PLANNING AND ZONING COMMISSION Tuesday, February 11, 2025, 4:30 PM 191 5th Street West, Ketchum, Idaho 83340

- 4. Recommendation to review and provide feedback on the Sawtooth Serenade Design Review Application (P24-0247)
- <u>5.</u> Recommendation to review and provide feedback on the Knob Hill Residence Pre-Application Mountain Overlay Design Review.

# CITY OF KETCHUM MEETING MINUTES OF THE PLANNING & ZONING COMISSION

2 1/16" = 1'-0" LOT DISTURBANCE DIAGRAM / DOUBLE LOT DEVELOPMENT

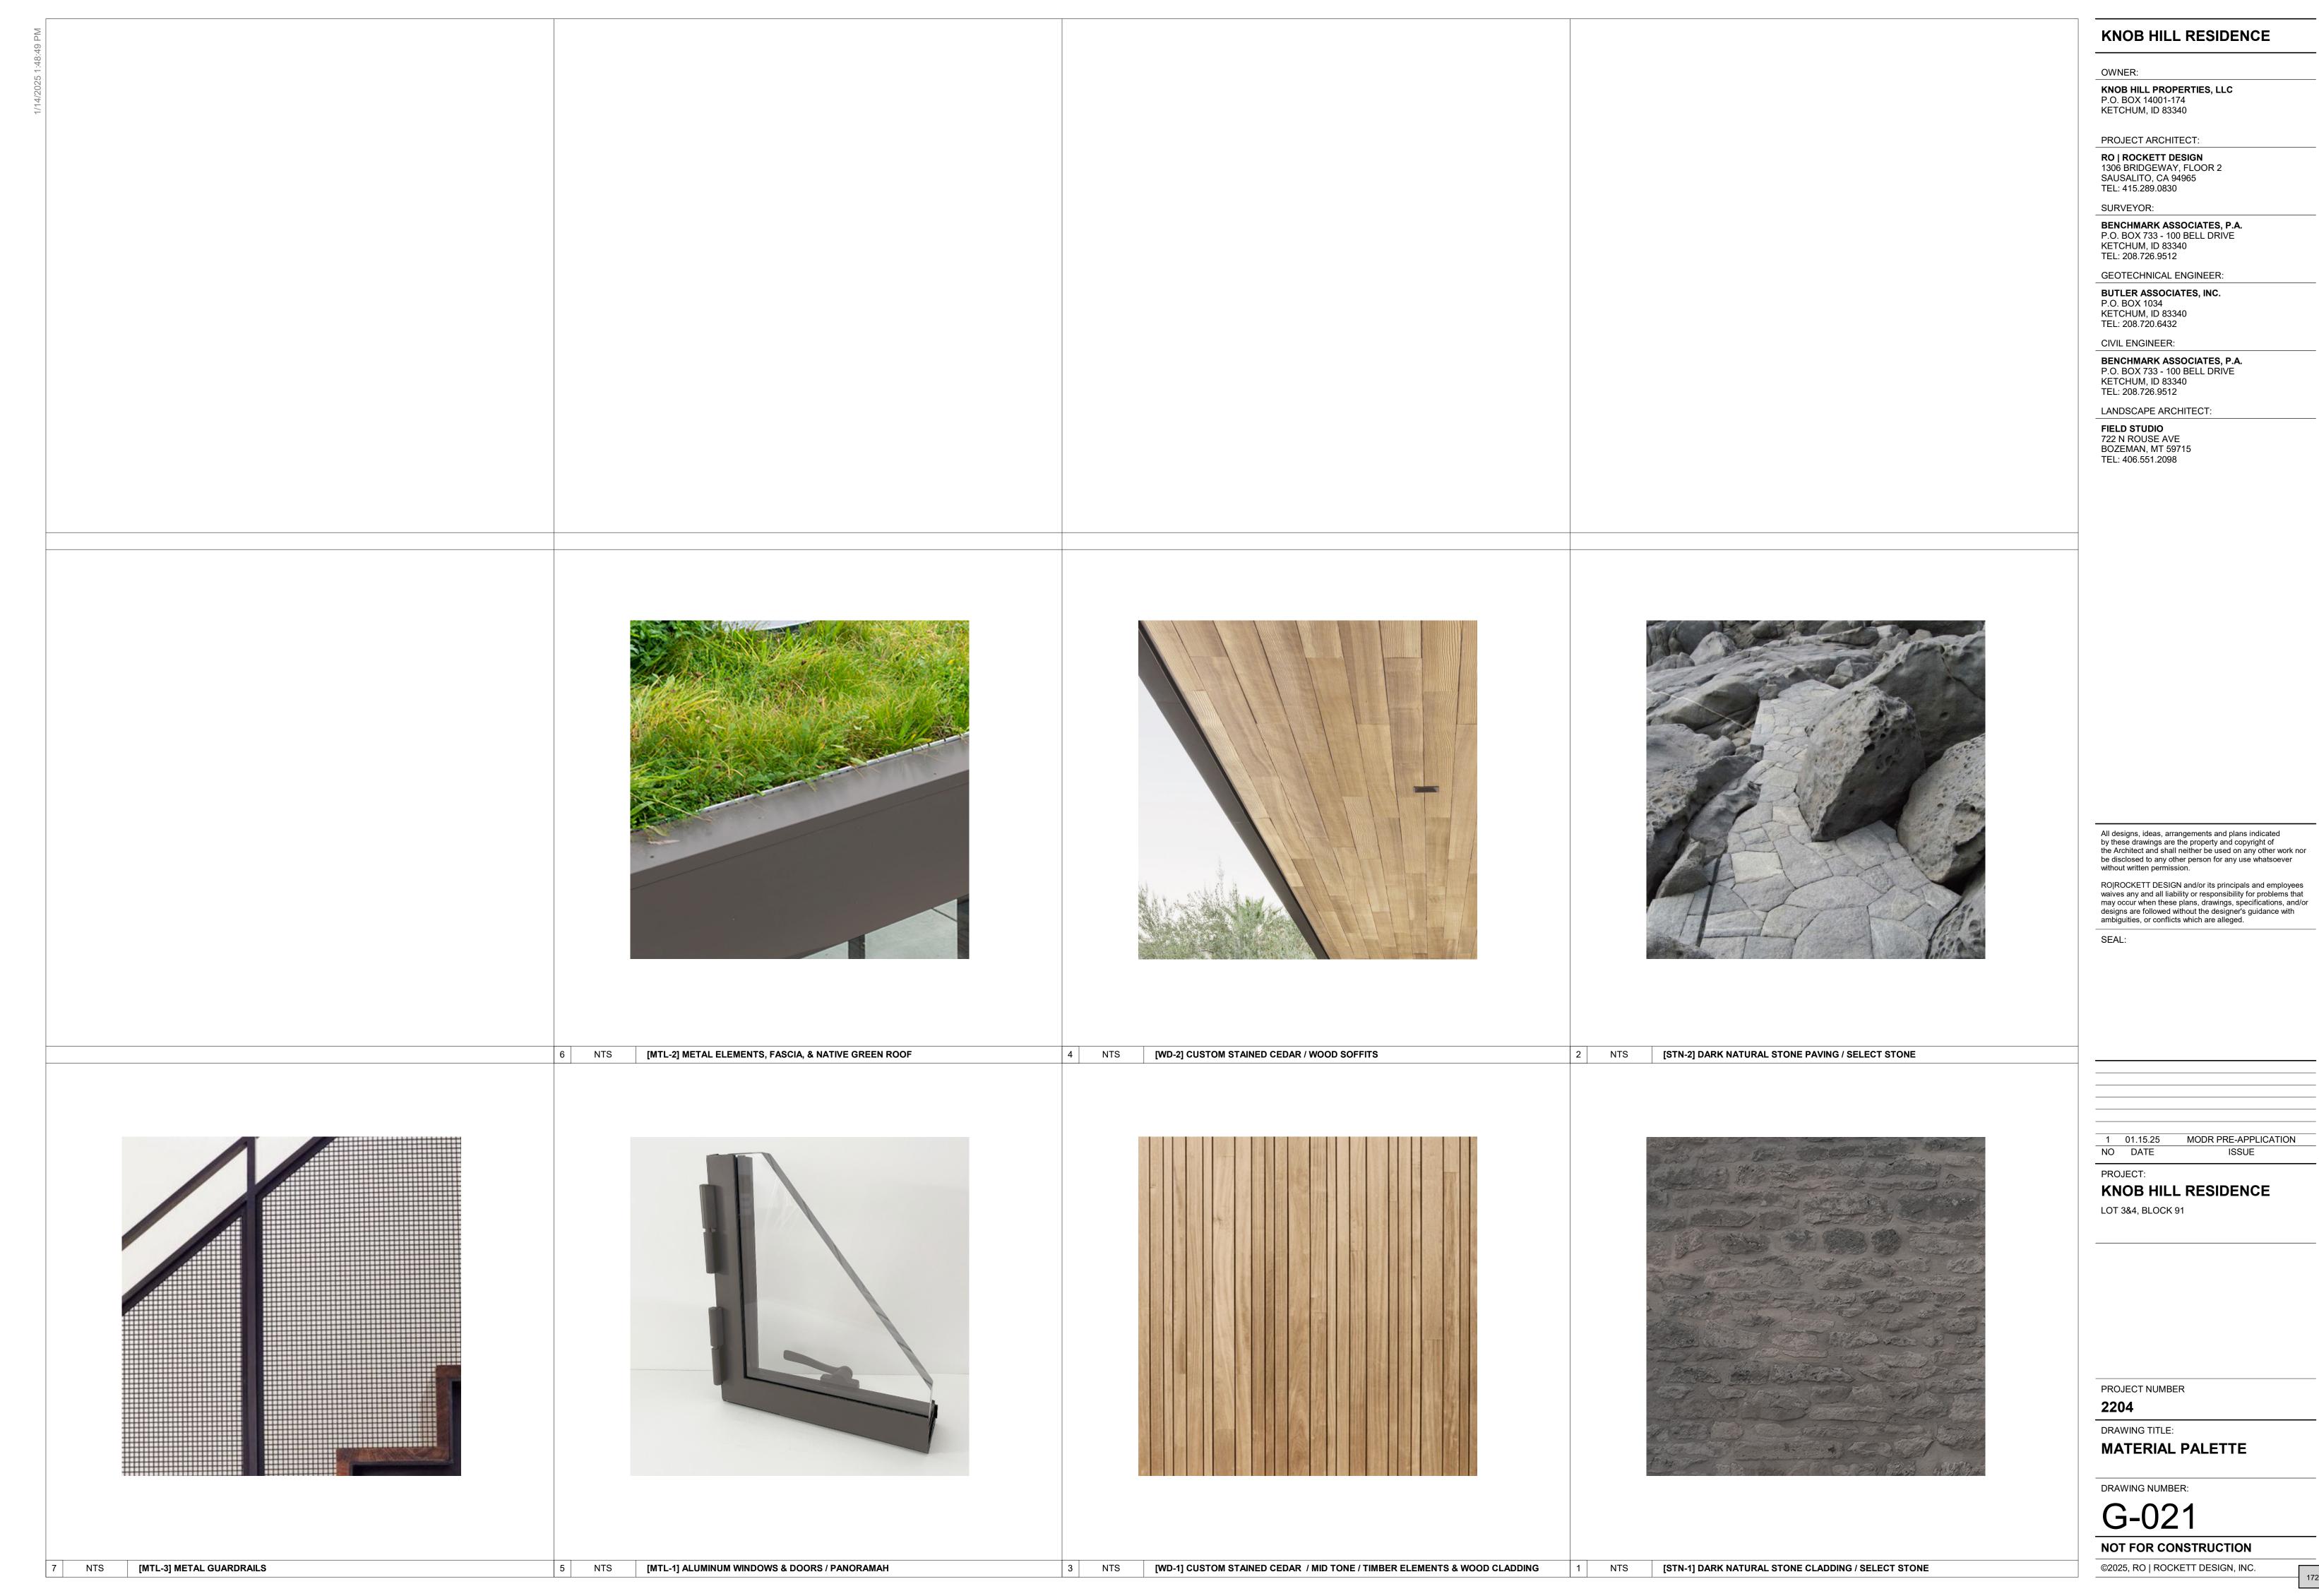
diagrams on sheet G-020 (see Figure 6), only a portion of the subject property along the rear property line is proposed to remain undisturbed. The total proposed undisturbed area is 1,660 square feet, which is only 10% of the subject property's total area. Hillside disturbance that is not associated with the building construction includes a small patio and hot tub at the northeast corner of the property as well as the driveway and fire apparatus access zone.

The design team has shown in our drawing package (Sheet G-020) that combining lots 3 & 4 for the development of a single home, rather than two homes, will increase the overall undisturbed hillside area by over 3x. The total amount of undisturbed hillside has also increased dramatically over the course of several months while working with the planning department. Compared to the initial plans for the residence, which included a larger outdoor program at the rear of the house, the proposed design limits rear yard access to a small patio and outdoor spa while bringing natural light and ventilation into an otherwise opaque side of the house. In the following exhibits you will see a progression that followed guidance provided by the planning department and preserves more of the natural hillside.
